CITY OF AUSTIN WATERSHED PROTECTION DEPARTMENT
BULL CREEK
OLD LAMPASAS #3 DAM MODERNIZATION
TREE MITIGATION AND REPLACEMENT

**ATTACHMENT 13
ENVIRONMENTAL RESOURCES
INVENTORY WAIVER**

Reference: Addendum – Environmental Resources Inventory Waiver
Rehabilitation for Old Lampasas #3 Dam on Tributary to Bull Creek
Austin, Texas
Baer Engineering Document No. 112009-8b.020

Reference: Environmental Resources Inventory Waiver Request
Rehabilitation for Old Lampasas #3 Dam on Tributary to Bull Creek
Austin, Texas
Baer Engineering Document No. 112009-8b.021

CHURCH SITE TCE

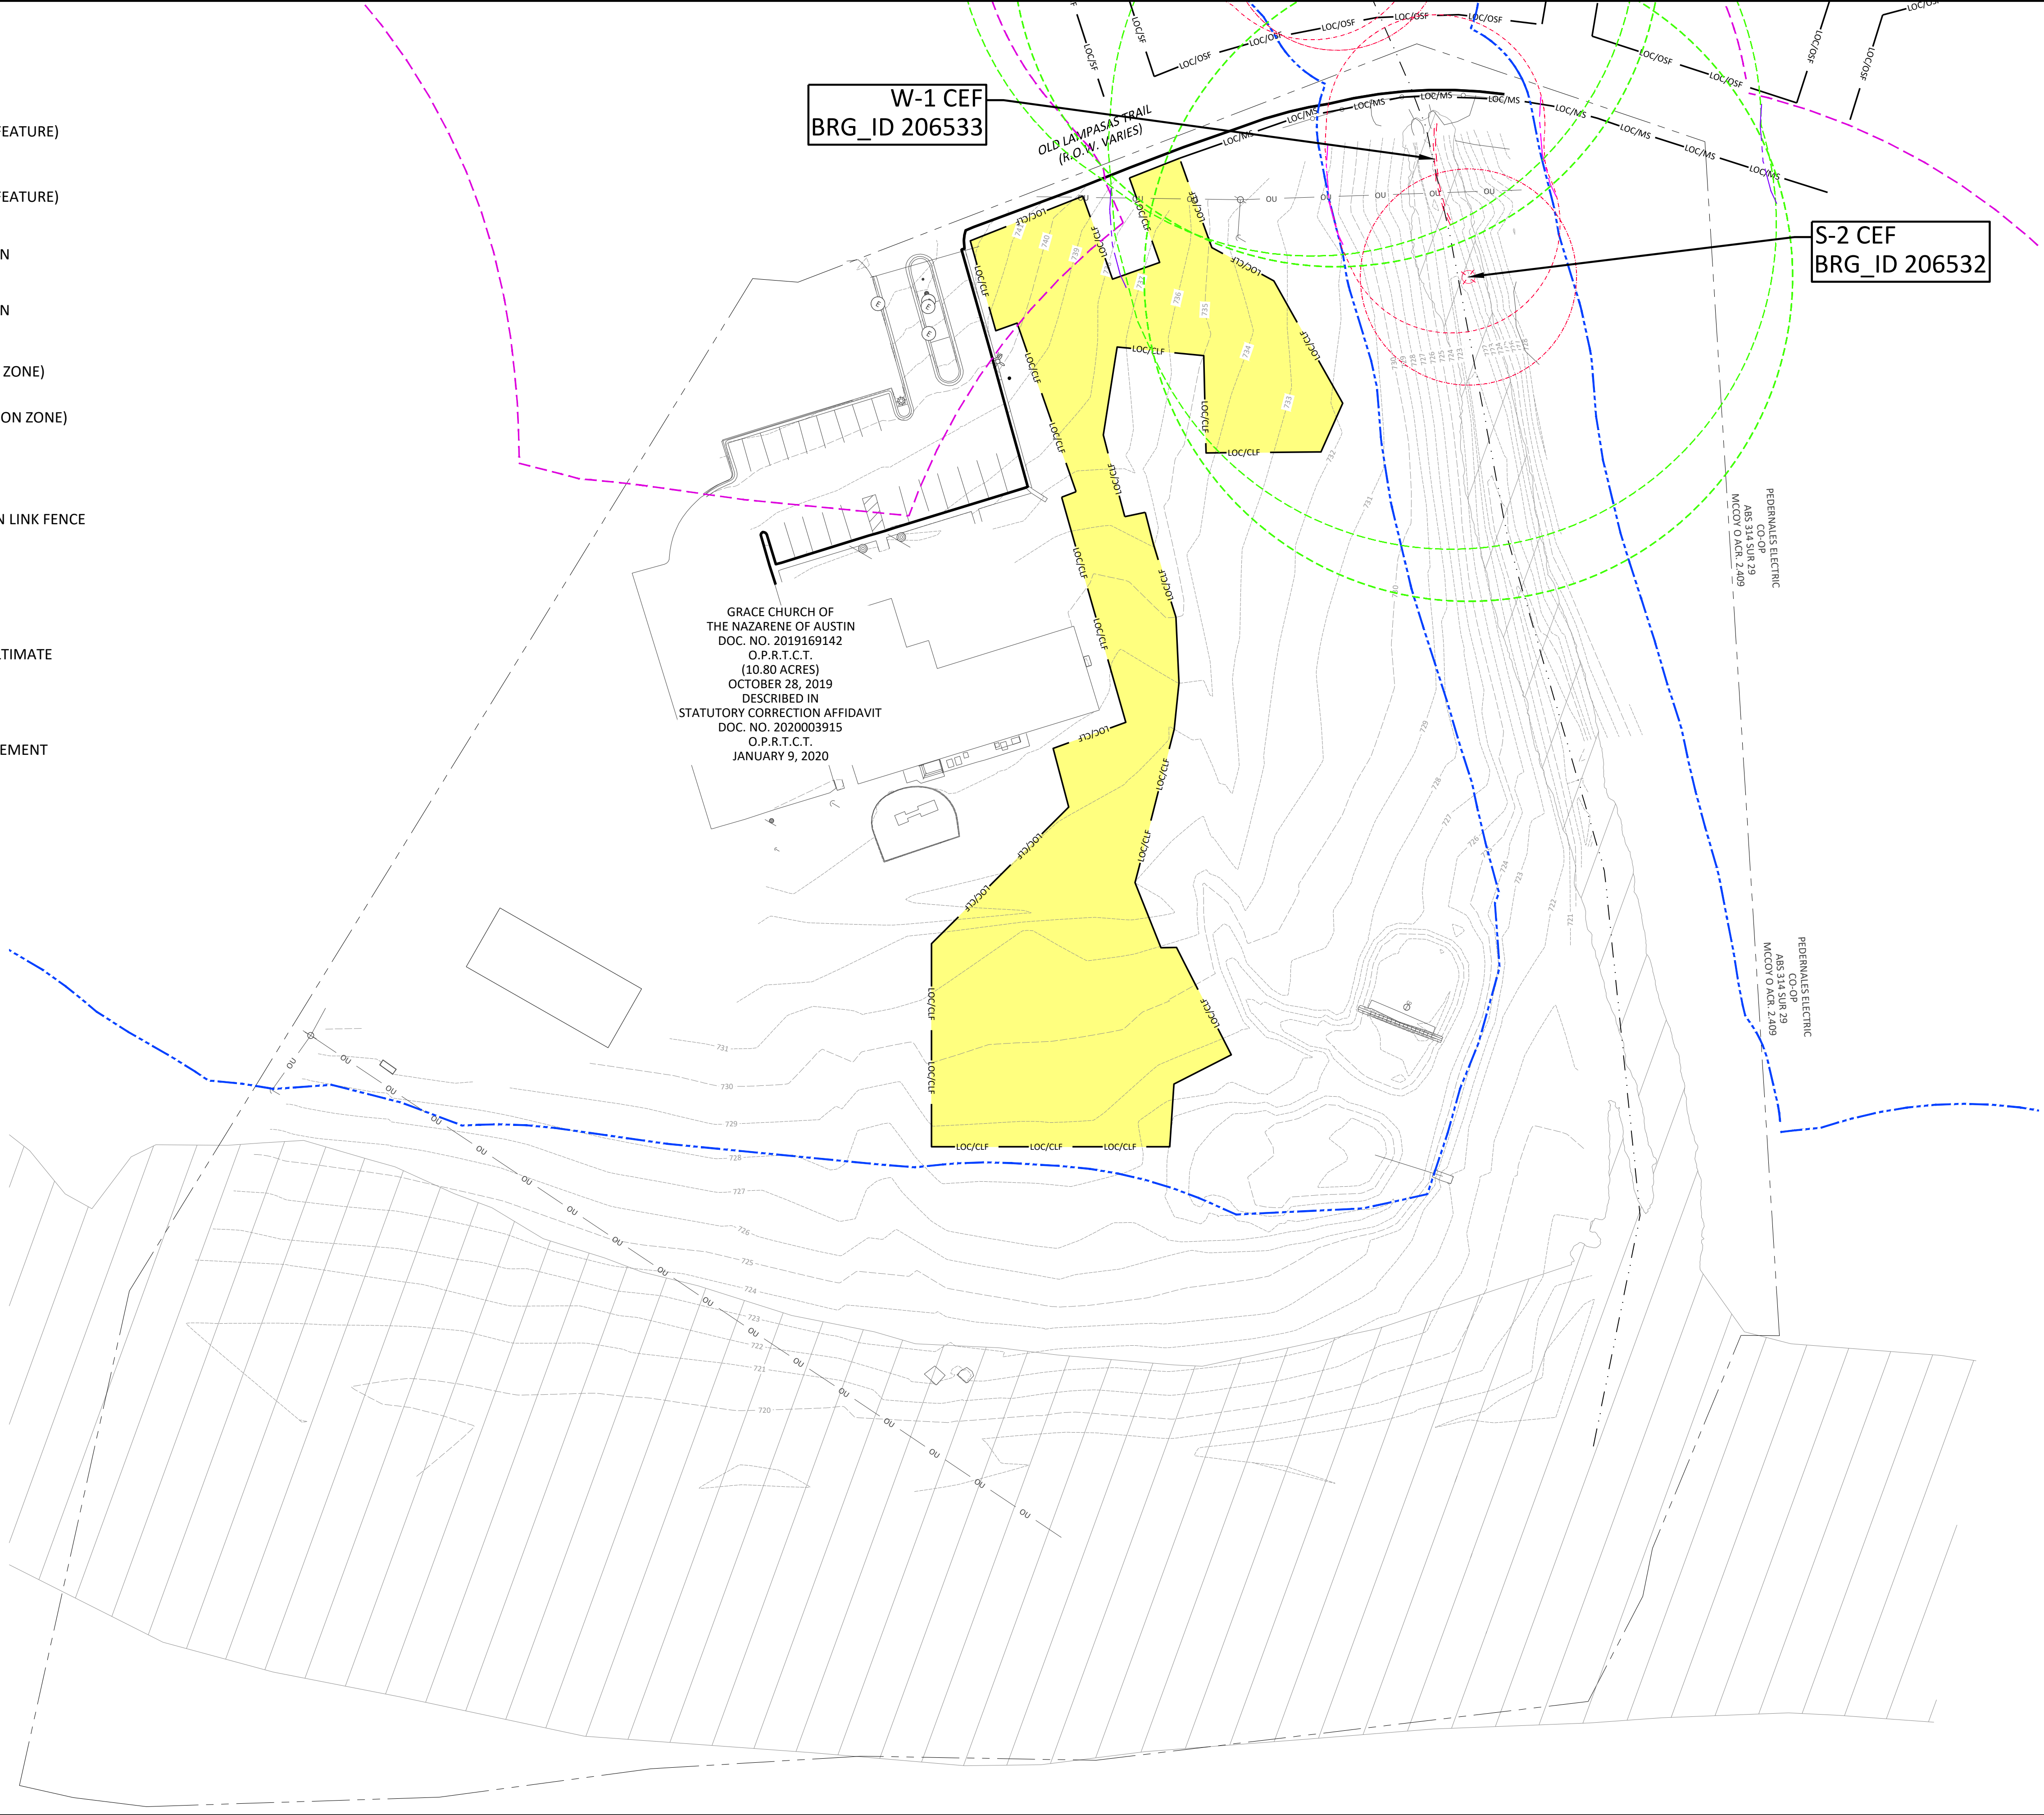
An additional area has been added to the project to be used for temporary construction staging. This area is on the property of Grace Church of the Nazarene (known as Central City Austin) at 9023 Old Lampasas Trail, Austin, TX 78750 (**Figure 1**). It is located south of, and on the opposite side of, Old Lampasas Trail from the Dam.

The new staging area avoids the CWQZ of Tributary 4A, the 100-year floodplain of Bull Creek, and the identified CEFs. The area is almost entirely within the WQTZ of Tributary 4A and overlaps with the 150-foot buffer areas around wetland W-1 (brg_ID 206533) and seep S-2 (brg_ID 203532).

The staging area will be temporarily disturbed by construction activity. Existing trees will be avoided and protected. No excavation or other significant ground disturbance will take place. Disturbances will be limited to those associated vehicle traffic and material storage. Tributary 4A will be protected

All CEFs on/adjacent to additional staging area known. Restoration/mitigation will be required in accompanying site plan review.
